Important Service Bulletin for the 2007 Subaru WRX and 2007 Subaru STi Potential Overboost Issues When Operating the Vehicle With a Catless Exhaust System v1.00

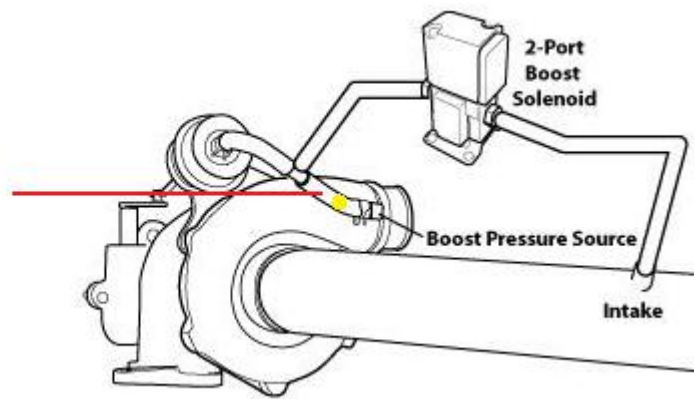
We suggest you replace these vacuum lines only after the engine and turbocharger system has sufficiently cooled down so you do not burn yourself on the hot engine components. Your engine can take up to 6 hours to fully cool down. The below diagram goes over the specific line you are supposed to remove and replace. The replacement vacuum line w/ restrictor from Cobb Tuning pill will have an orange paint mark. Please be sure to re-use all factory hose clamps.

Carefully remove and replace this vacuum line with the provided replacement vacuum line containing the larger restrictor pill. Be sure to re-use all factory hose clamps.

install two items from your local Subaru dealership. The first item is Subaru OEM part # 09535A060, which is a replacement vacuum line where the restrictor pill will be located. The second item is Subaru OEM part # 22326KA120, which is a new restrictor pill that has a center hole machined to 1.20mm or .047". The total retail cost for both of these items should be less than \$6 USD. The restrictor pill will need to be carefully inserted in the middle of the vacuum line so the air can pass through the restrictor pill. It does not matter which way the restrictor pill faces as long as the machined hole is perpendicular to the hose and air can pass through the pill.
